Comments on CAST-19

A review of CAST-19 was initiated on February 21, 2020 with a request for the WQGIT and the Watershed Technical Workgroup (WTWG) to provide comments. Presentations on the changes between CAST-17d and CAST-19 were made to the WTWG on March 5, 2020 and again on April 2, 2020. Presentations were made to the WQGIT on March 23, 2020 and April 27, 2020. Comments were received from DE, MD, PA, VA, and WV. Meetings were held with each of these states to address their comments. DC and NY did not provide comments. This document is a summary of all comments received and the resolution of each comment.

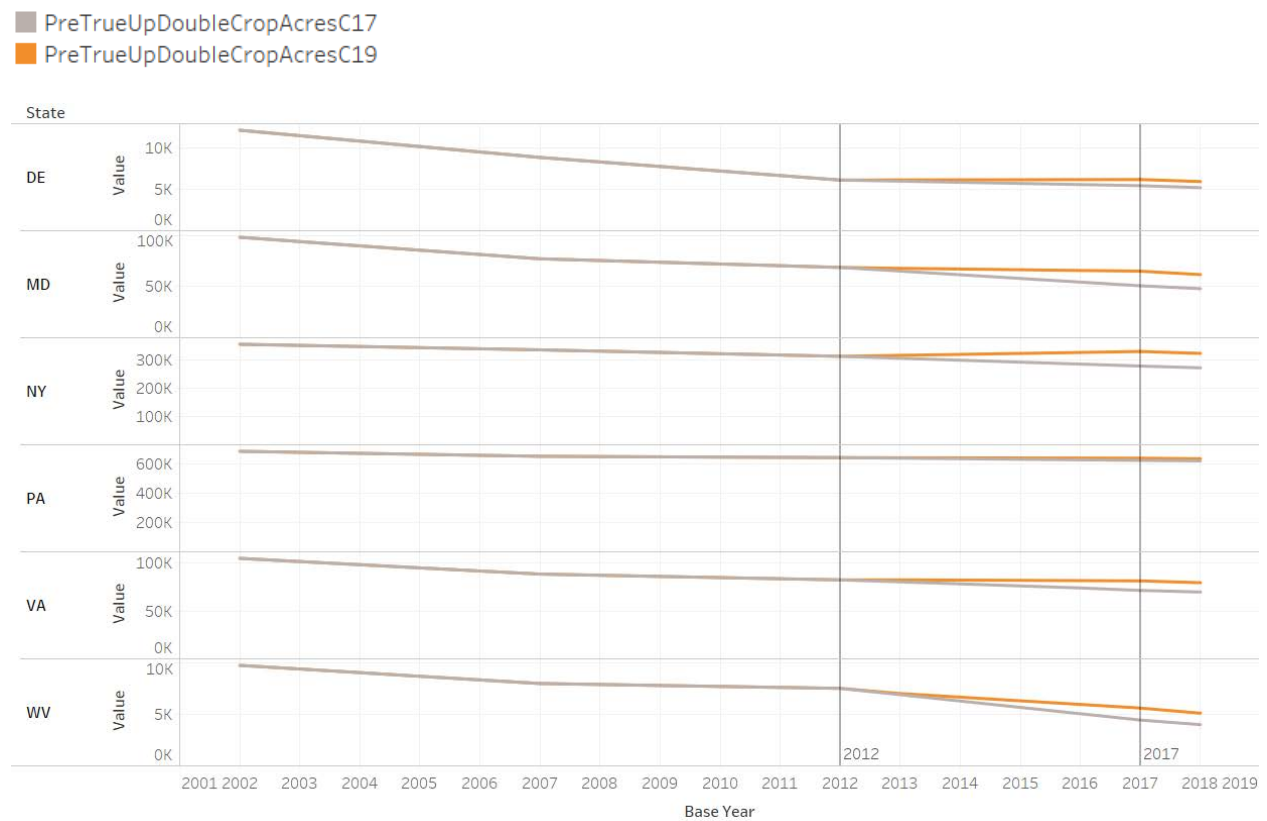
Comment—Dairy animals

There was initial confusion when looking at the difference between the dairy animal numbers for a single year. CAST-19 shows more dairy animals than CAST-17d.

Dairy animals have been decreasing over time. The rate of decrease has been faster than was predicted using the 2017d Agricultural Census. However, these numbers do not reflect an increase in dairy animals in the watershed. Rather, the amounts show that the decreasing trend was not at as high a rate as was projected. The line graph below illustrates that both versions of CAST show a decrease.

Data are shown as line graphs so the entire trend of dairy animals over time is clear.
